APPEAL APPLICATION

Regarding Case Number: VTTM No. 73427; CEQA ENV-2014-3995-EIR

Project Address: 9503 N. Andora Place, Chatsworth, CA

Appeal of Entire Decision dated March 30, 2017
Re: 9503 N. Andora Place
ENV-2014-3995-EIR; CEQA ENV-2014-3995-EIR
VTTM No. 73427

Impassable terrain features within area letter of determination indicates as viable corridor width, taken 9-19-2016.

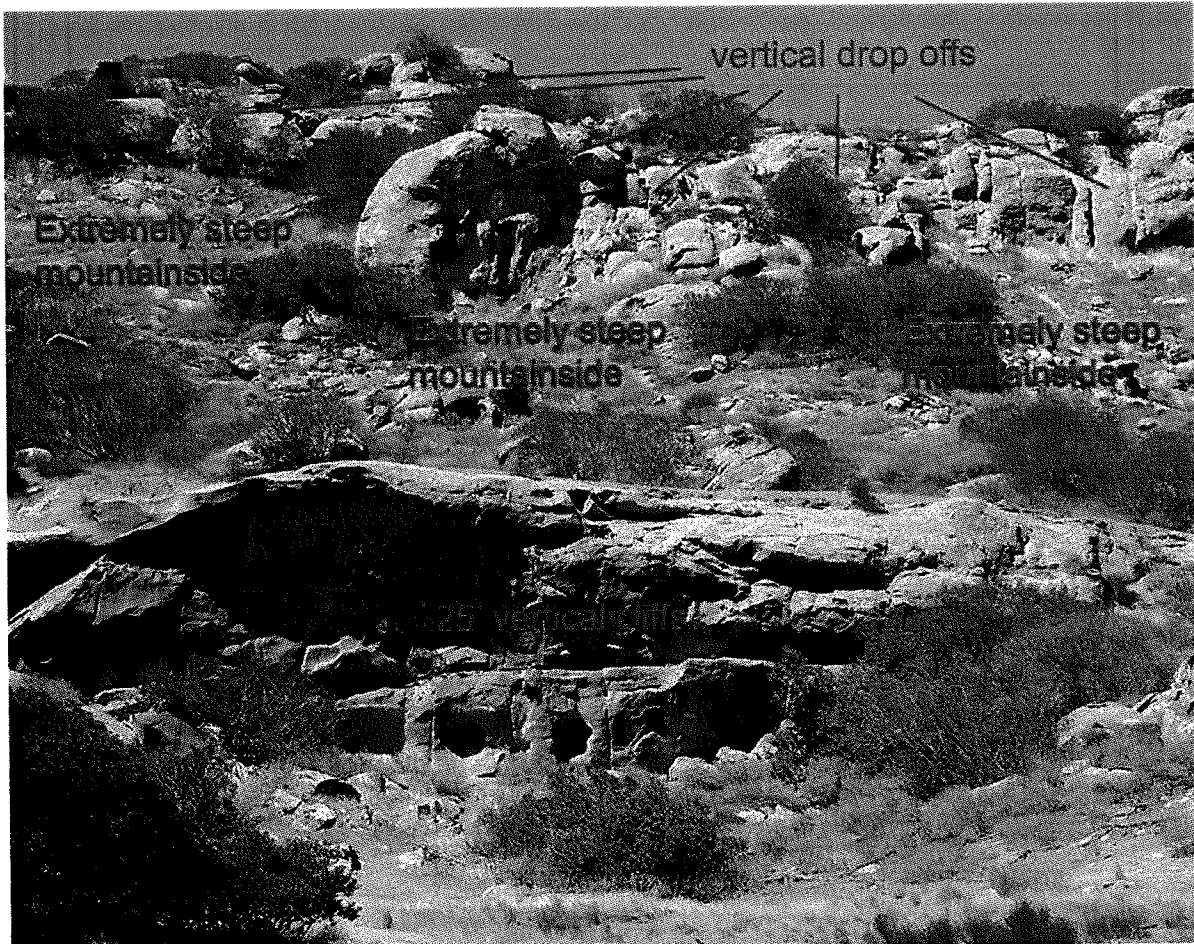
It must also be noted that the 1500' width expanse cited above (in the project site's western portion) contains and directly abuts large expanses of impassable terrain, including 90 degree cliffs hundreds of feet wide (see first photo next page), bordered and surrounded by extremely steep mountain side and more vertical drop offs (see second photo next page), making the cited area poorly suited to wildlife passage. The EIR fails to note that the eastern portion of the project site has terrain much better suited to a wildlife corridor, including an ephemeral stream bed whose much gentler-sloped hillside is easier for animals to traverse, and is filled with denser brush and plants favored by animals for cover and safety.

EIR Figure III-1 Wildlife Linkage map detail, 1080' measurement of narrowest corridor dimension overlaid

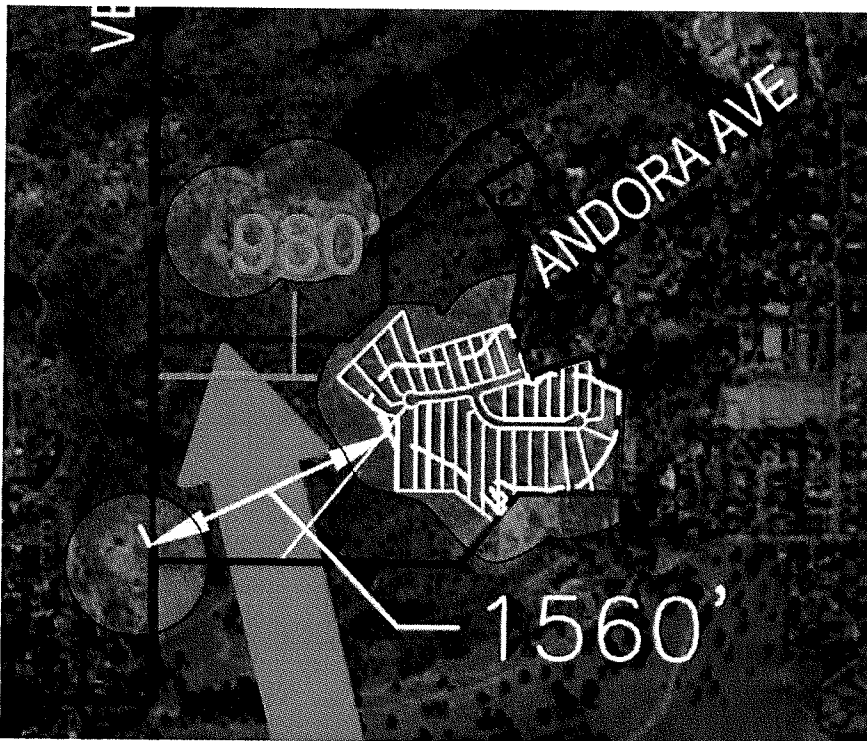
The EIR falsely states the proposed plan secures a 1560'-wide wildlife corridor. It arrives at this number through a series of omissions and blatant lack of understanding of corridor basics.

The EIR further fails to factor in edge effect losses on that width, from the project itself and two neighboring properties located near the project site's southwest corner. Though the EIR fails to apply

edge-effect losses to the false 1560' width, it does discuss the edge effect at length in a later section of the EIR, determining edge effect to equal 300': "Taking into account all these factors, it would be reasonable to expect a certain area would be subject to household noise, dogs barking, home and auto alarms which could deter occupation by less urban-tolerant species. This zone would probably not exceed 300 feet in length from the edge of development." The following illustration shows edge effect losses that should have been applied in EIR corridor-width analysis. The edge effect further reduces the EIR's false width to about 980'.

EIR Figure III-1 Wildlife Linkage map detail, overlaid with terrain losses from vertical cliffs and extremely steep mountainside. Approximate area of terrain losses indicated by red.

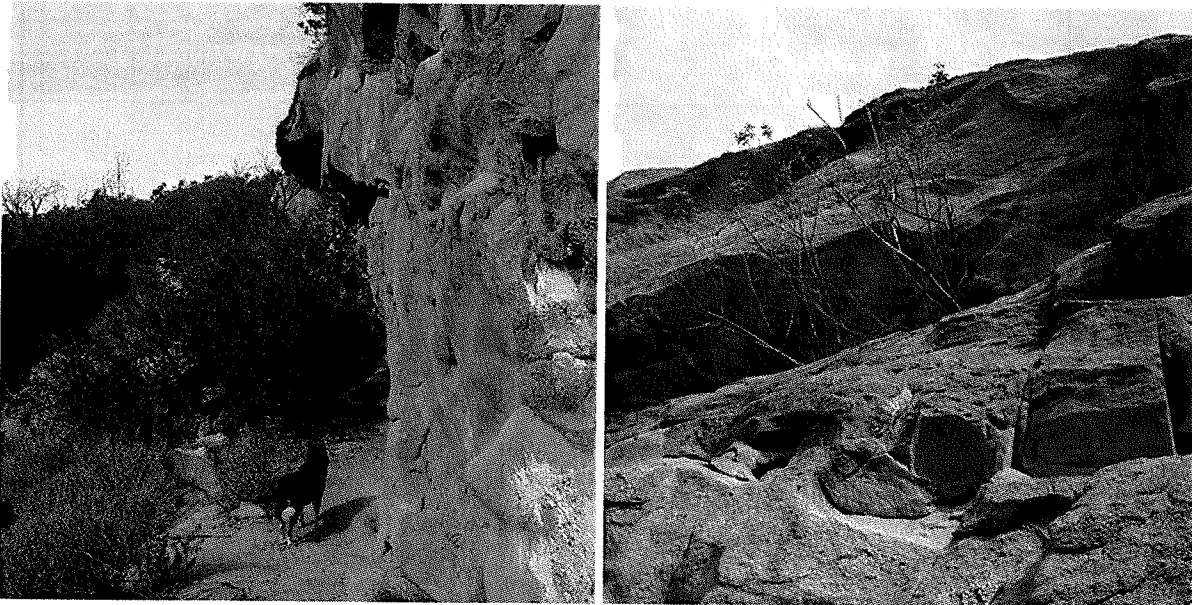
The EIR's flawed analysis also ignores determining factors of terrain on corridor width. The corridor path as routed on the Wildlife Linkage map (orange arrow) is in actuality blocked by excessively steep terrain including vertical cliffs up to 25 feet tall. Those vertical cliffs and steep terrain are indicated on the following map in red, indicating impassable or difficult-to-traverse terrain. As shown, topographic realities further reduce viable corridor width to approximately 450'.

Photos documenting impassable terrain features within zone which EIR indicates as viable corridor width, taken 9-19-2016. Photos were taken of and within terrain indicated by red in preceding map.

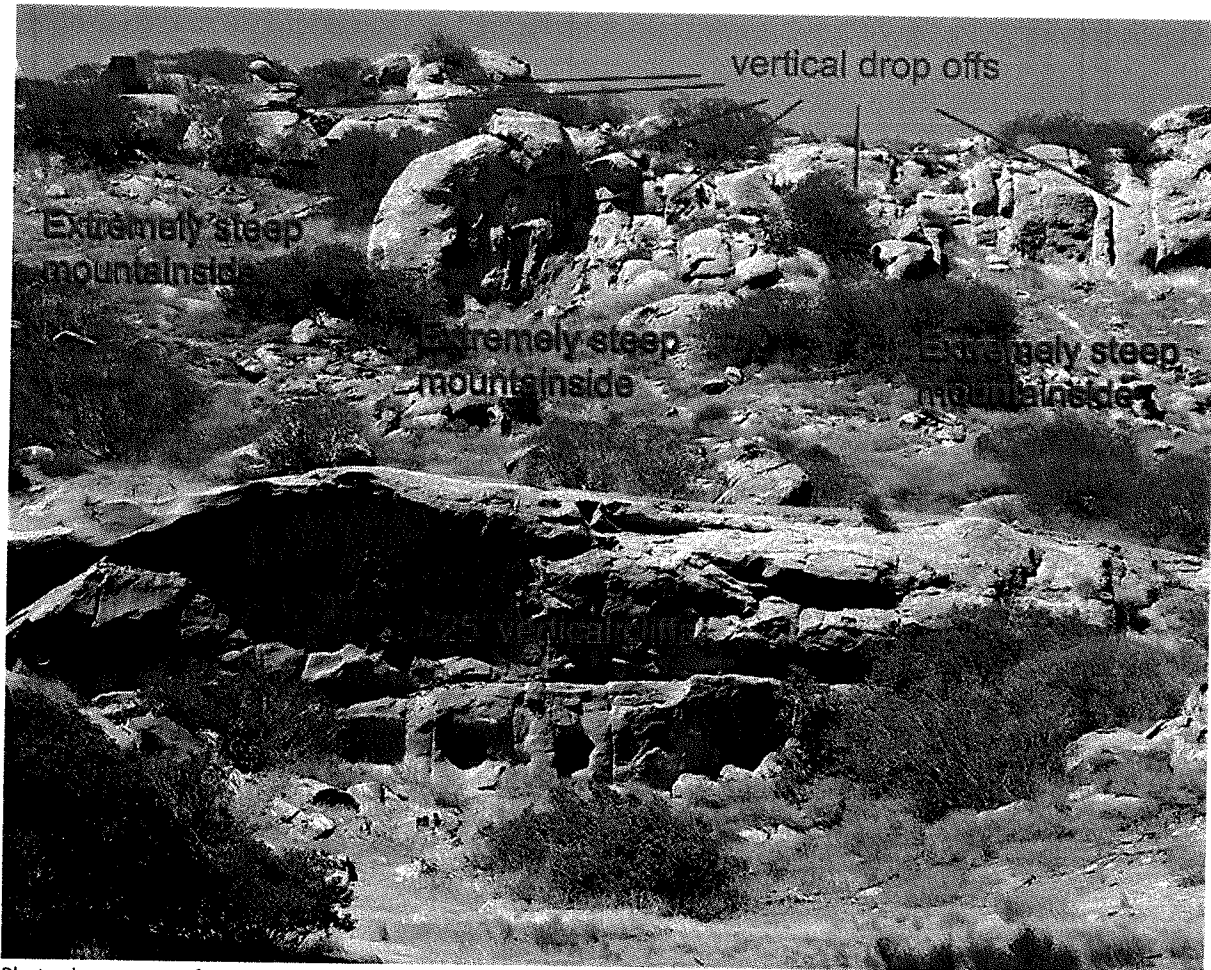
The following photos taken within the above map's red zone document impassable cliffs, near-vertical drop offs and steep hillside.

Map shows wildlife corridor following canyon favored by wildlife.

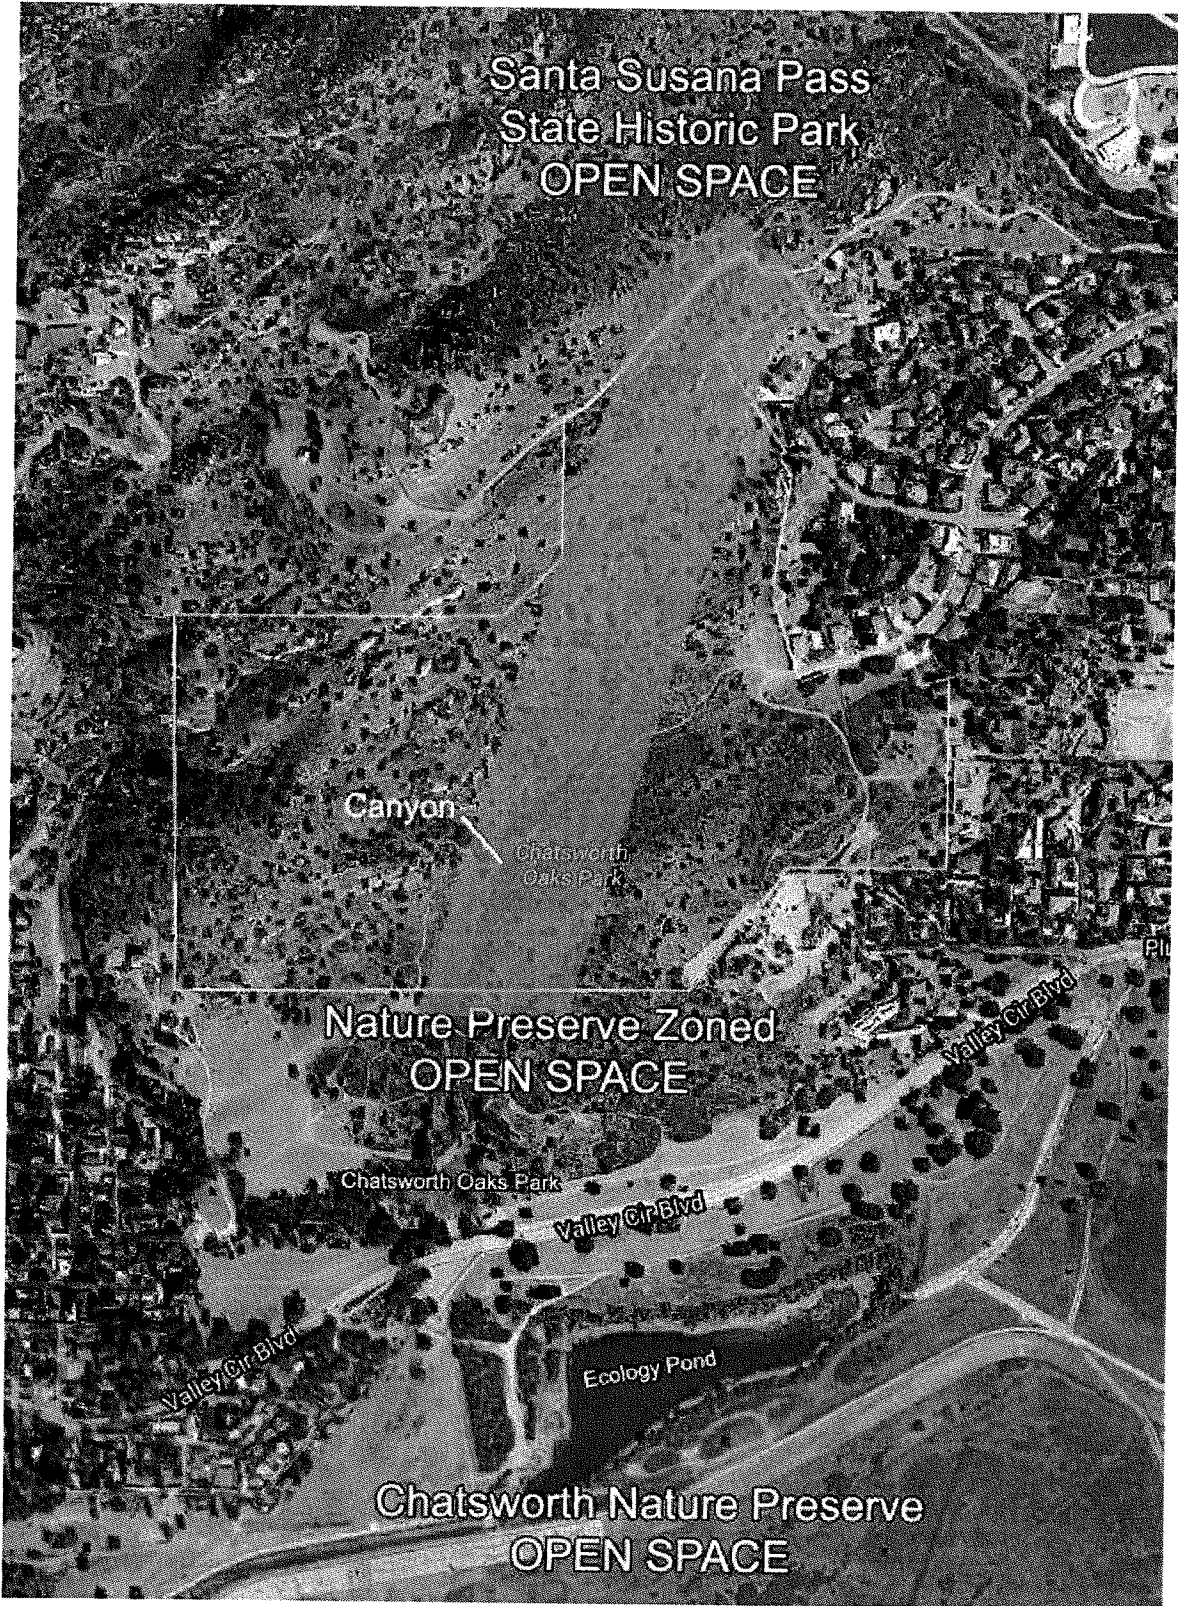
The EIR maps illustrate an imagined wildlife corridor on the project site's western undeveloped portion. In actuality, animals are much more likely to traverse the much-gentler sloped canyon located in the eastern developed portion of the project site. That canyon, which contains a seasonal stream, also houses dense, protective brush favored by transiting wildlife.

This canyon, favored by wildlife transiting through the project site, is the property's actual, real-world wildlife corridor (see map on next page).

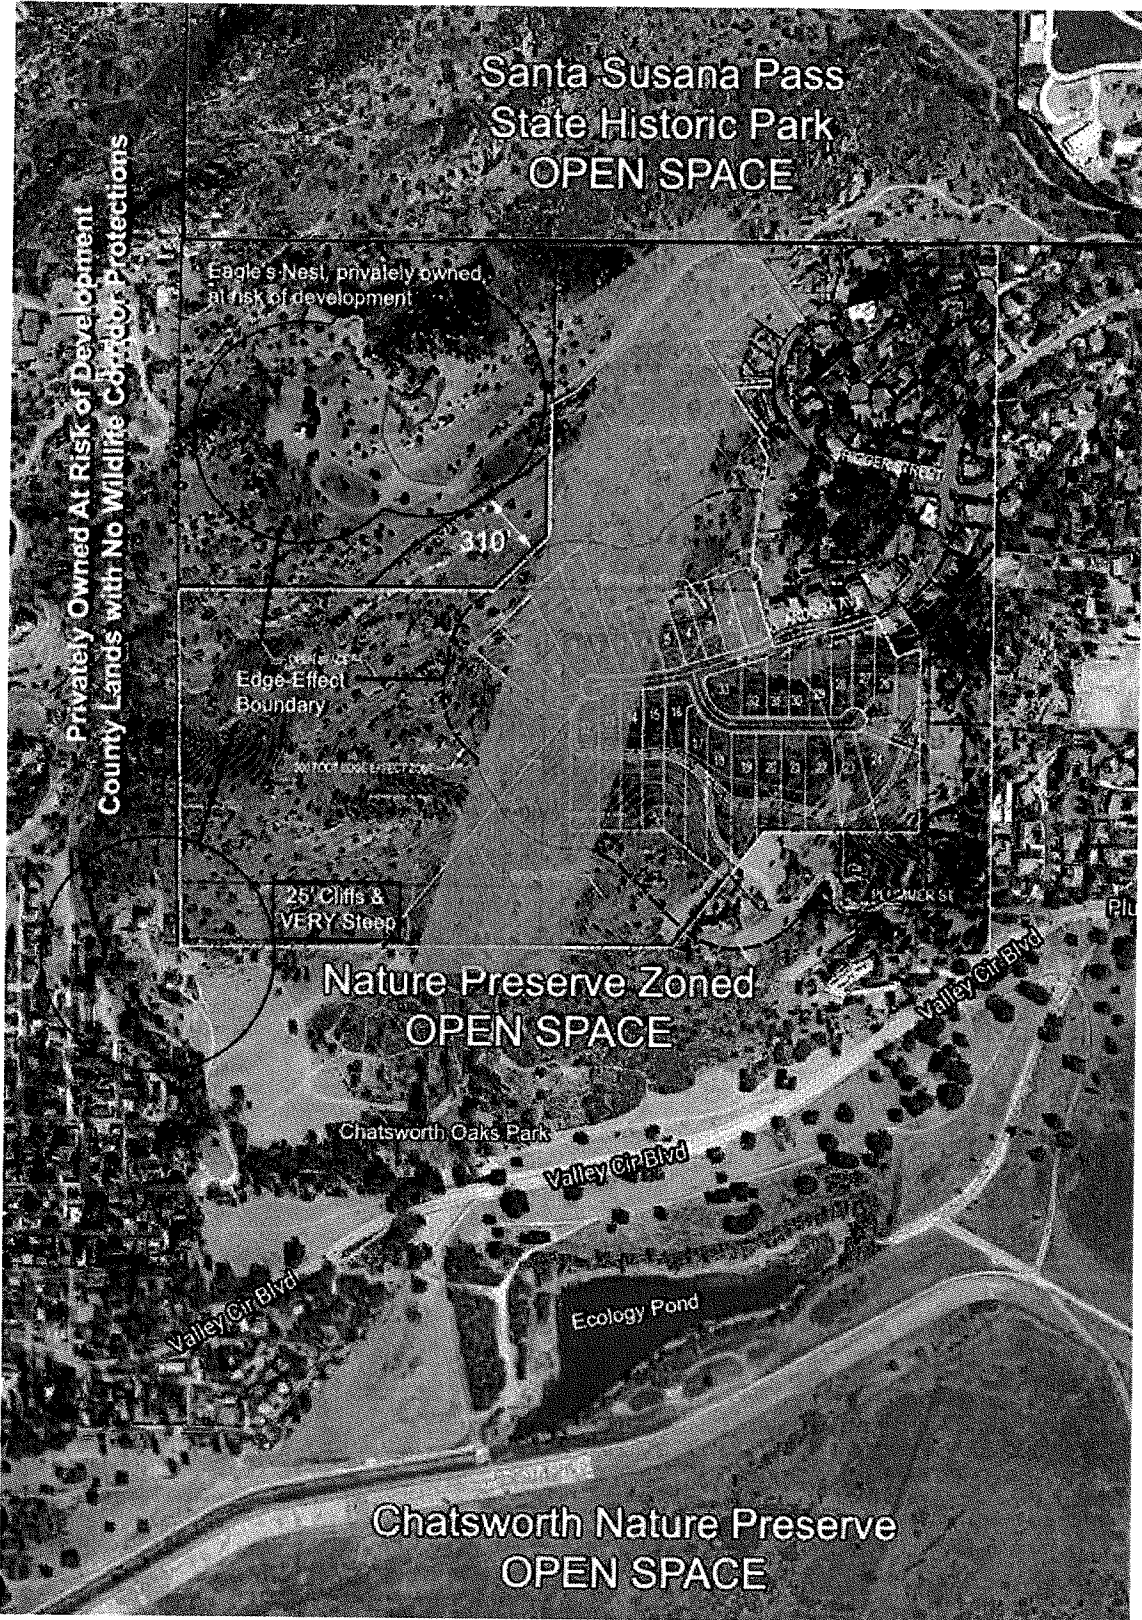
The site's wildlife corridor travels up the canyon smack into the proposed project's development site. In fact, the project's development footprint and edge effect would completely eliminate the current wildlife corridor within project-site boundaries. The developer purchased a trapezoid-shaped property which would secure an approximately 310'-wide passageway (measuring its narrowest pinch point).

The following figure (see next page) starkly illustrates the project proposal's devastating impact on the site's wildlife corridor. The corridor itself is indicated via a green arrow, the trapezoid property by blue, the project site by yellow.

With edge-effect losses for Eagle's Nest applied, it becomes clear the 310'-wide trapezoid would be the only viable corridor width remaining in *all of Los Angeles City*, if this project proceeds as currently configured. Edge effect for Eagle's Nest's two developed structures was determined in this document using the EIR's Edge Effect terms: 300 feet from the edge of development. It should be noted that prior owners of Eagle's Nest hotly pursued subdivision and development in the past; that property should therefore be considered at high risk of future development.
